FOI reference: 21-097

## LETTER OF DESIGN REVIEW

Developer: Hindmarsh Constructions  
 Address: 81 Constitution Avenue Campbell ACT 2617  
 Contact: [REDACTED]  
 Project Title: Campbell Section 19 Block 28 (Stage 2)  
 Consultant: Sellick Consultants P/L  
 Address: PO Box 5005 Braddon ACT 2612  
 Contact: [REDACTED]  
 TCCS Project Lead: Ruwan Abeysekera

DRAWING TITLE: PLAN - SITE  
 SCALE: 1:200 @ A1  
 DATE: 2018

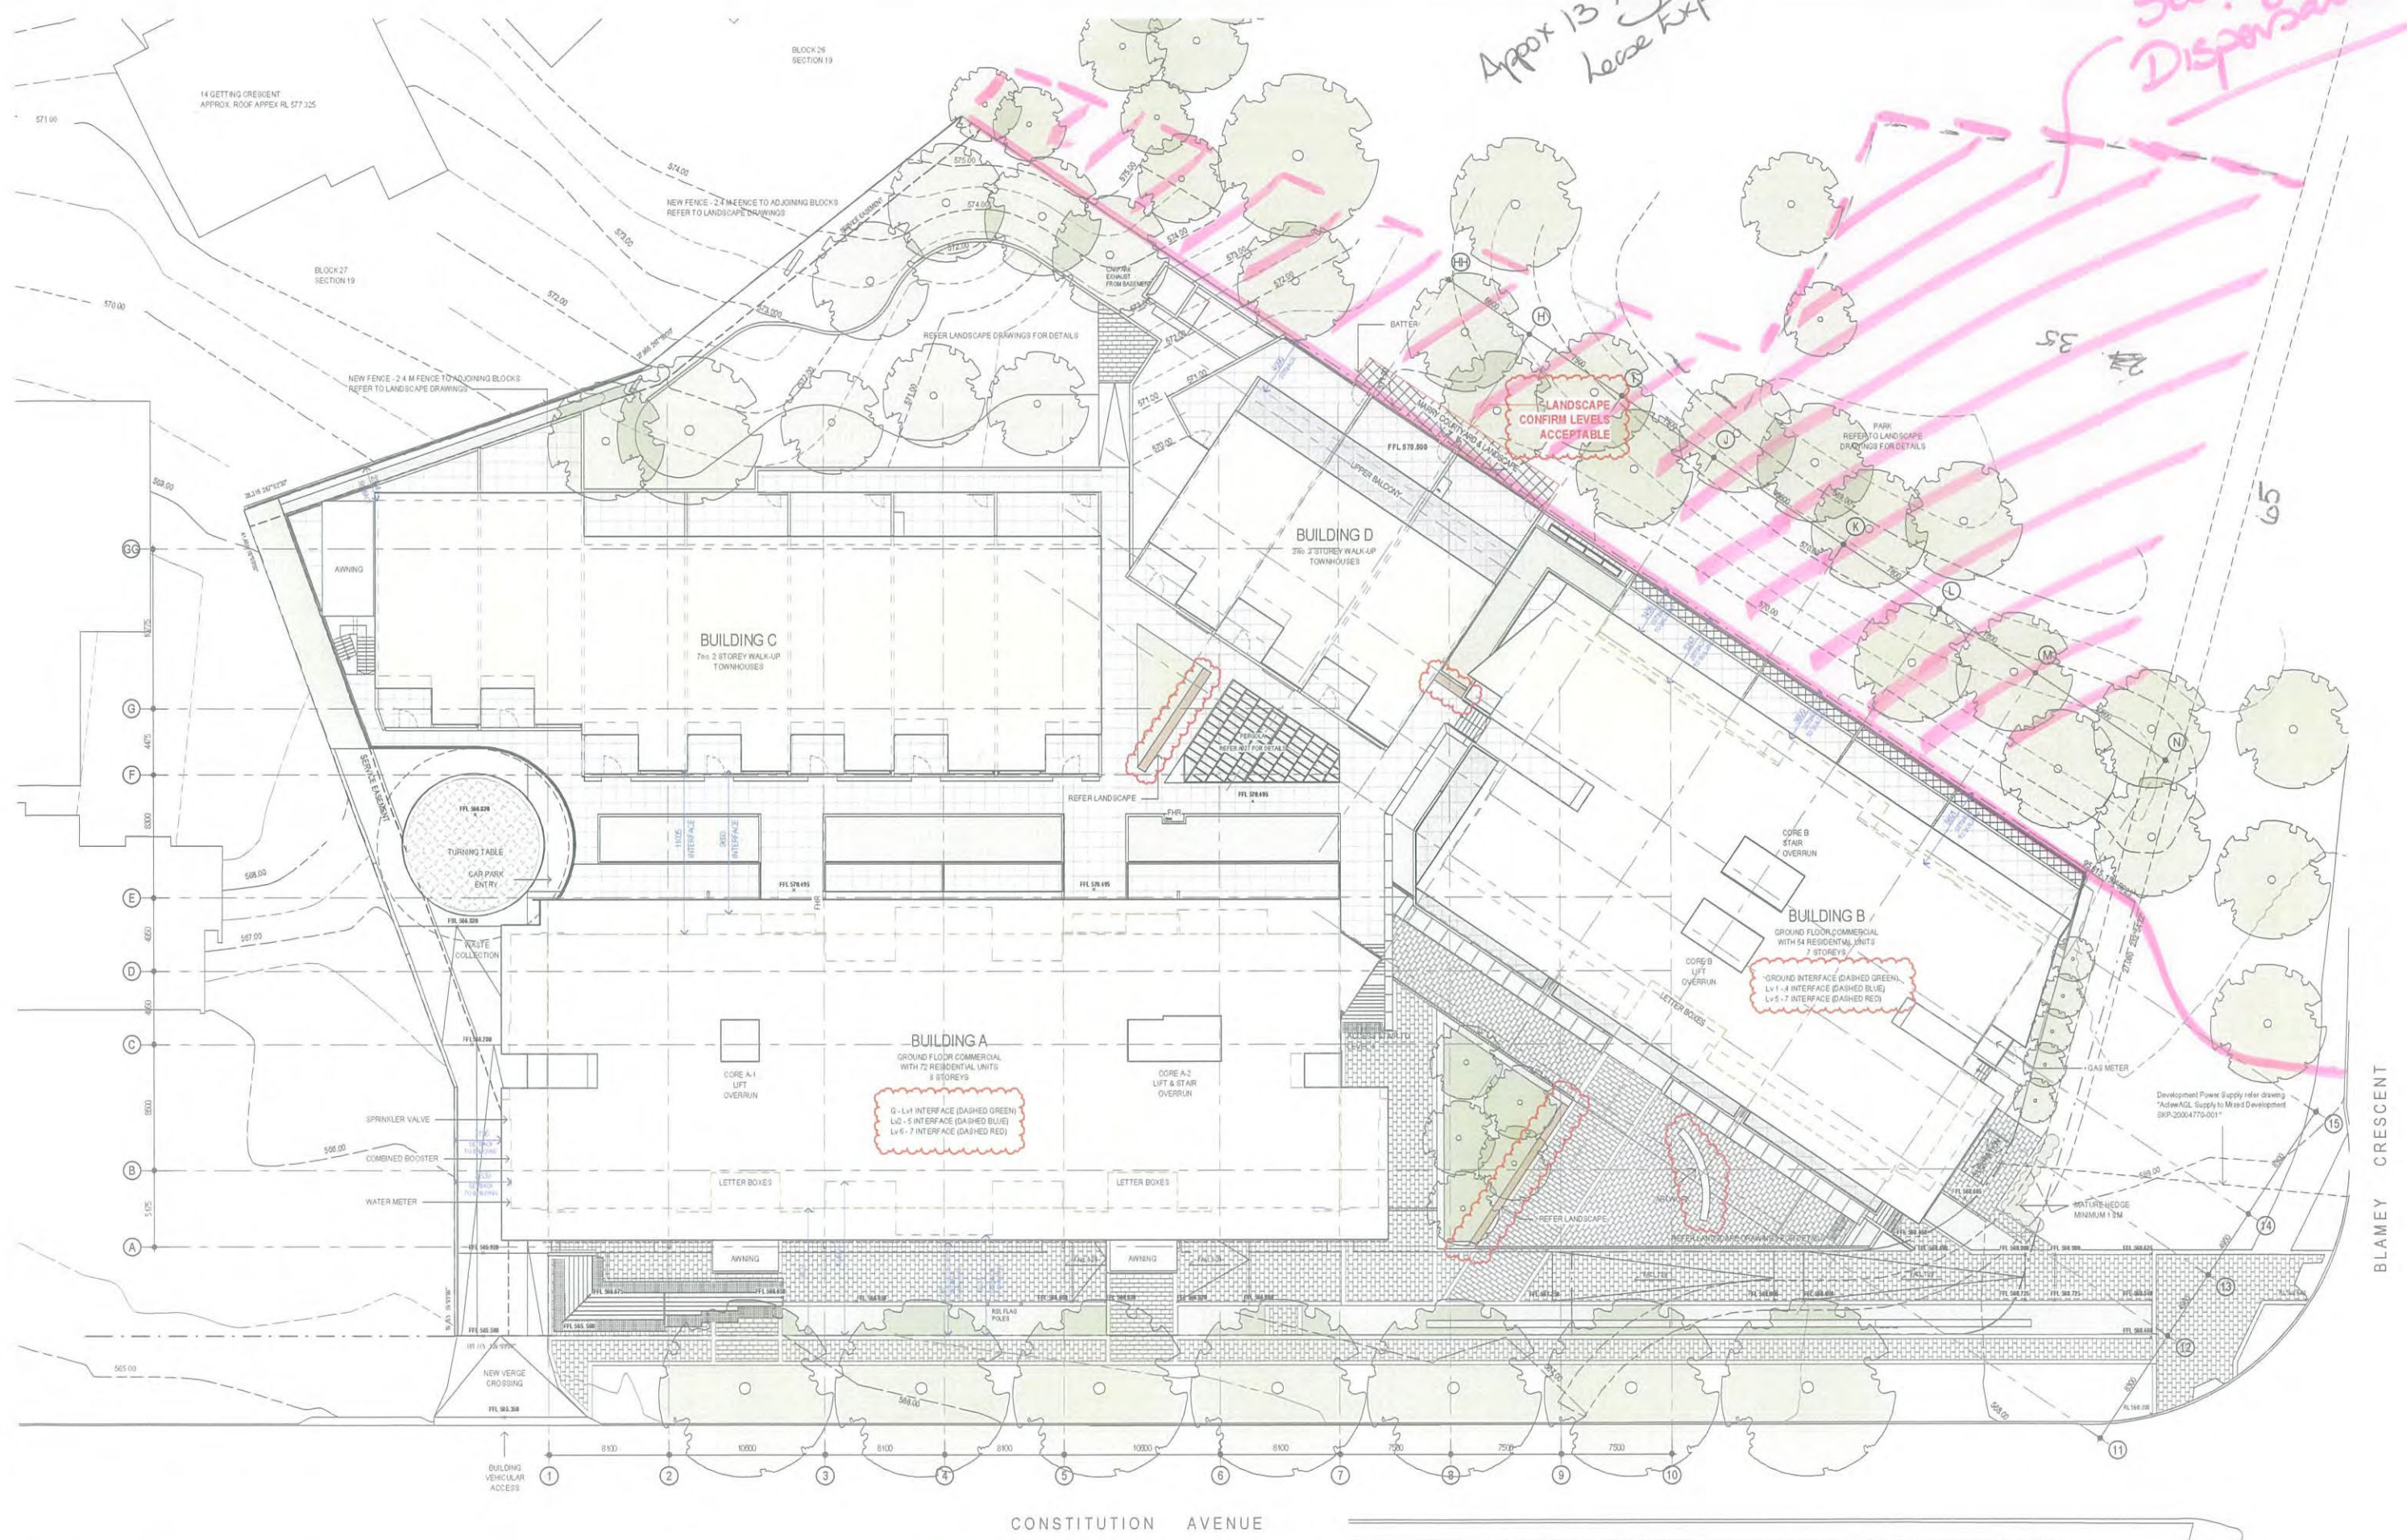
Thank you for your email and the attached staging plan for Operational Acceptance Submission. It is not very clear which elements are included in stage 2. Please list down the off-site work intended to hand over in stage 2.

TCCS can approve the two stages for Operational Acceptance as per the below email and the attached sketch plan. However, the final acceptance must submit as one submission after the defects liability period of both stages. Please complete and send back to me the attached acknowledgement form for stage Operational Acceptance.

DRAWING TITLE: PLAN - SITE  
 SCALE: 1:200 @ A1  
 DATE: 2018

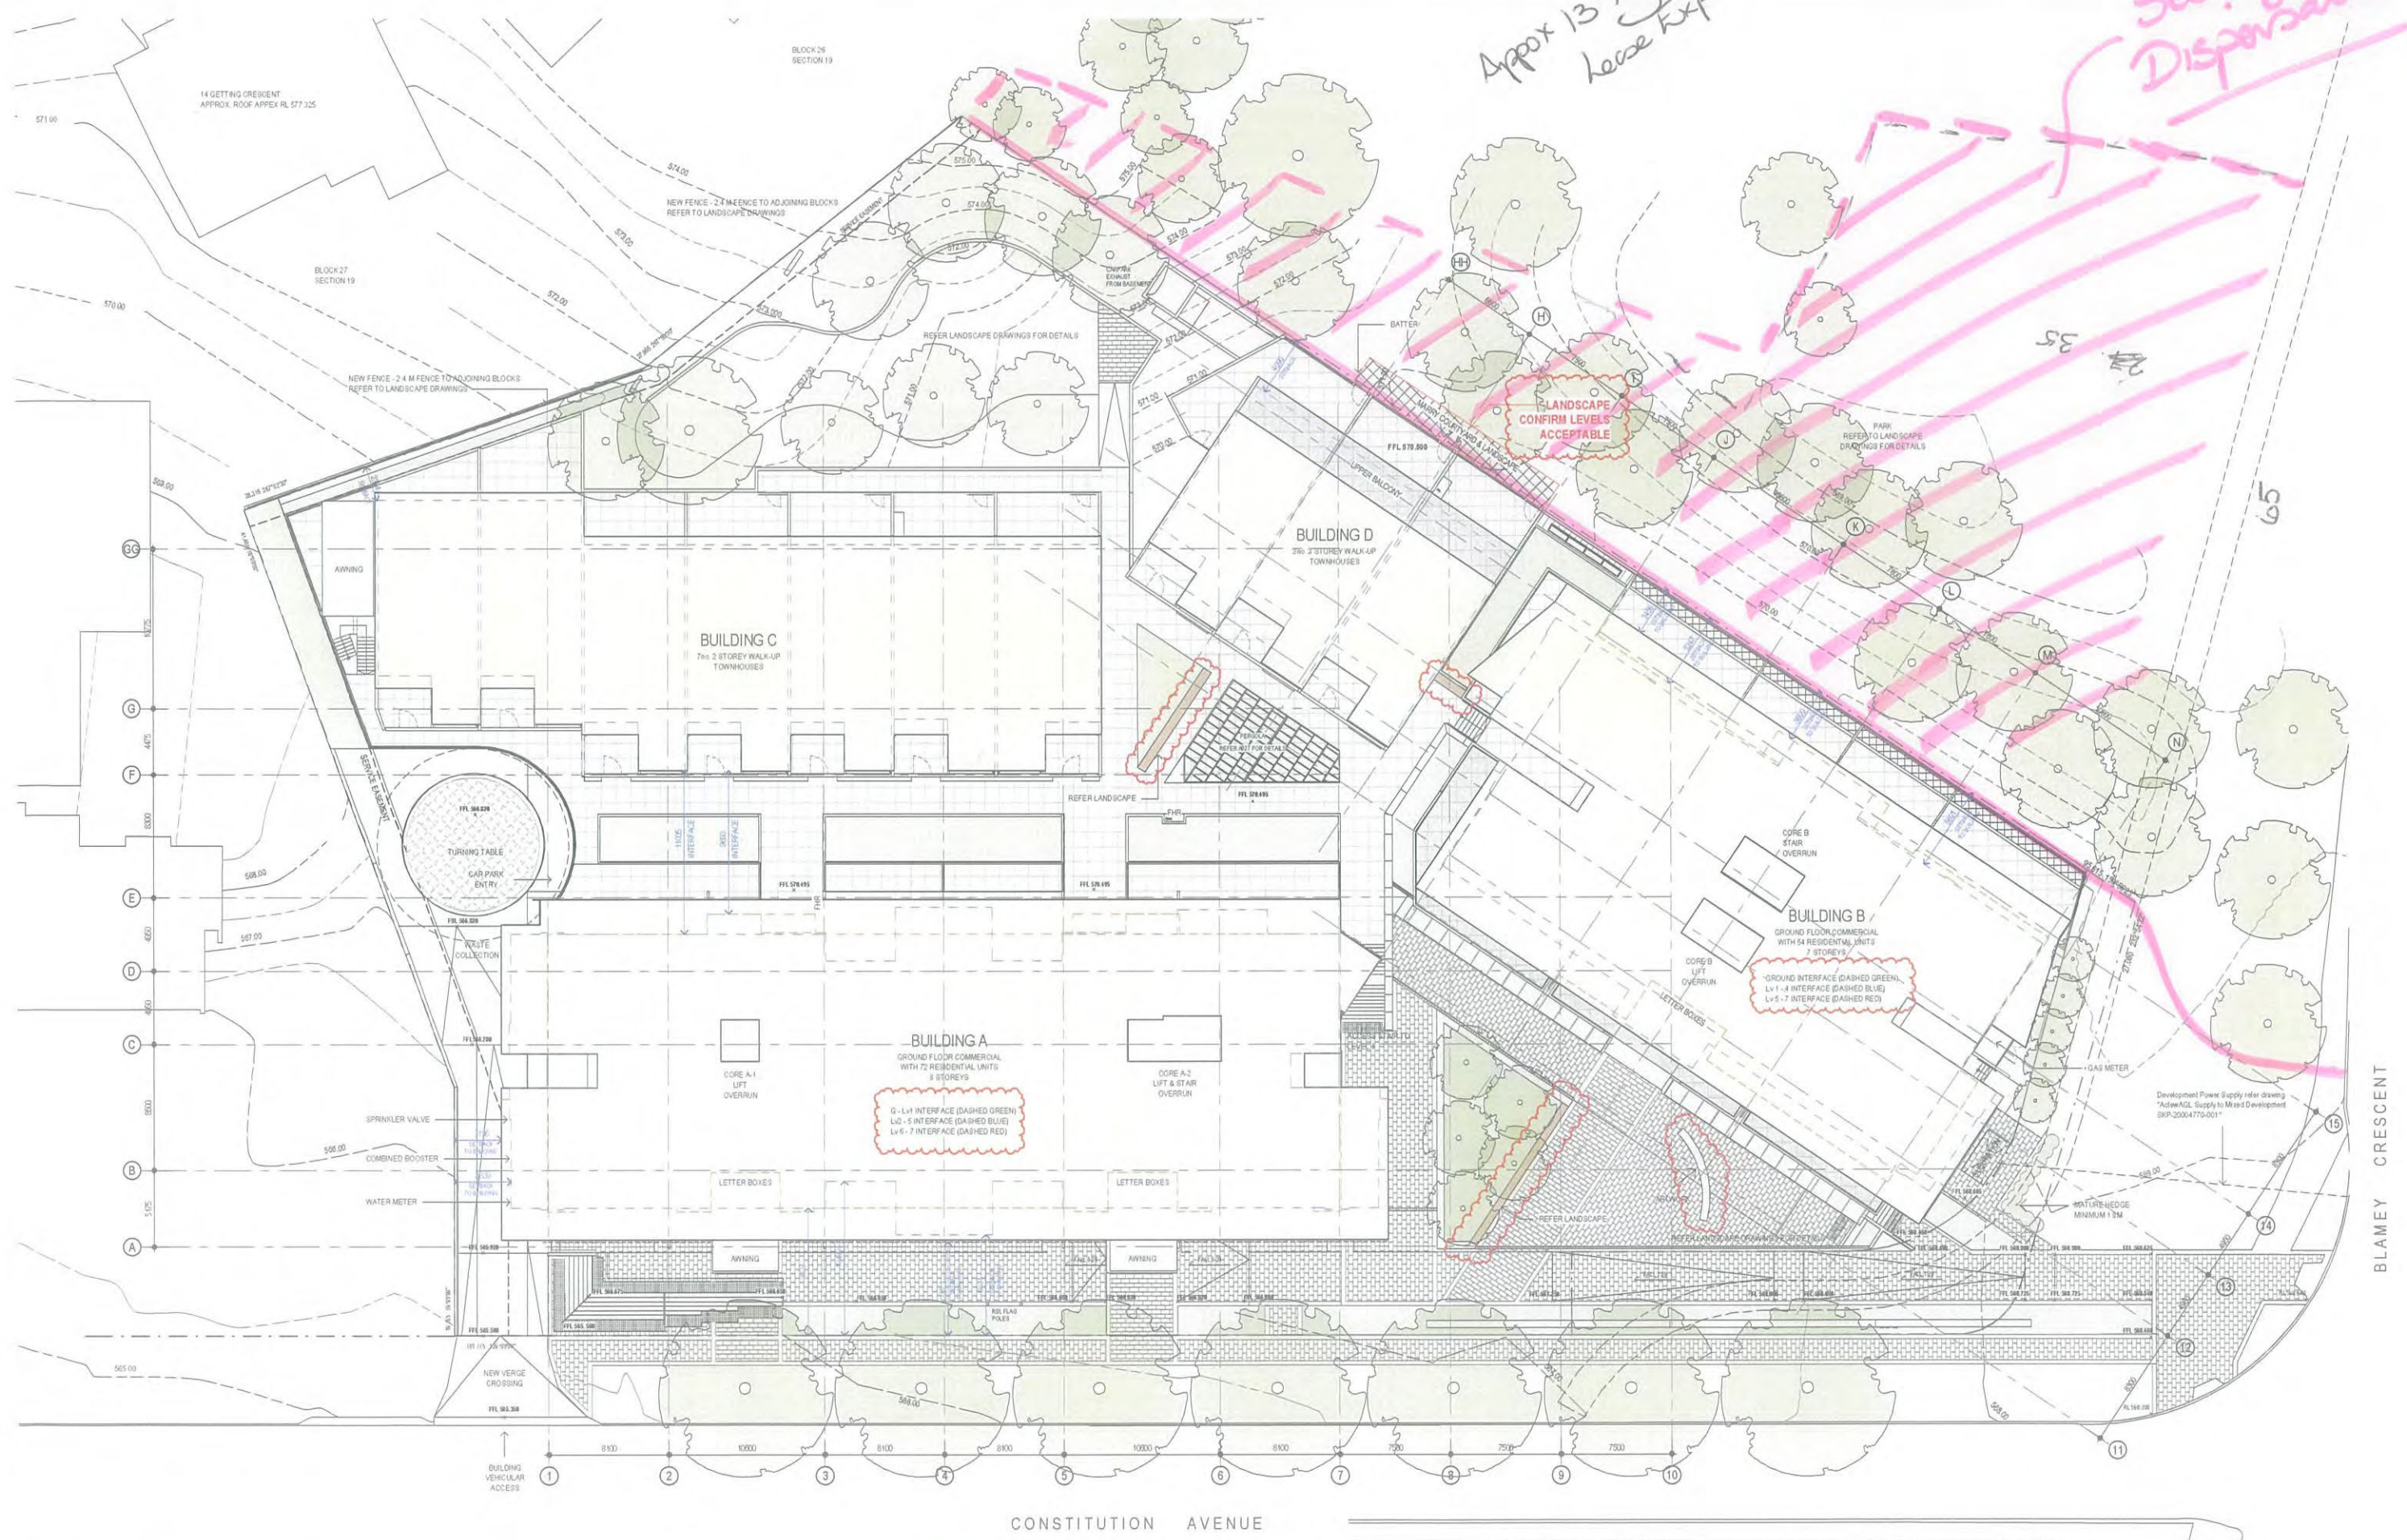
Thank you for your email and the attached staging plan for Operational Acceptance Submission. It is not very clear which elements are included in stage 2. Please list down the off-site work intended to hand over in stage 2.

TCCS can approve the two stages for Operational Acceptance as per the below email and the attached sketch plan. However, the final acceptance must submit as one submission after the defects liability period of both stages. Please complete and send back to me the attached acknowledgement form for stage Operational Acceptance.
